# Access Compliance Report Public Rights-of-Way (Curb Ramps)

Main Street: ACANTHUS Cross Street: MORNING\_TRAIL Location: NW

ADA ID: RPRK211021123206 Ramp Type: Type 4 - Parallel Initial Pass/Fail: Fail Overall Compliance: No Severity Score: 15

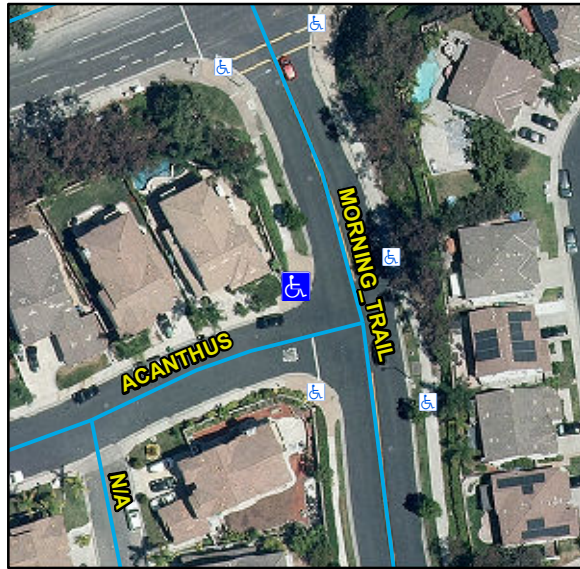
R204.3, R304.5.3, STD 1115

| Compliance | Description                   | Data       | Compliance | Description                   | Data |
|------------|-------------------------------|------------|------------|-------------------------------|------|
| No         | Ramp Cross Slope LT (%)       | 6.8        | No         | Ramp Cross Slope RT (%)       | 6.4  |

Remove & Replace Curb Ramp With Two New Directional Ramps or Equivalent.
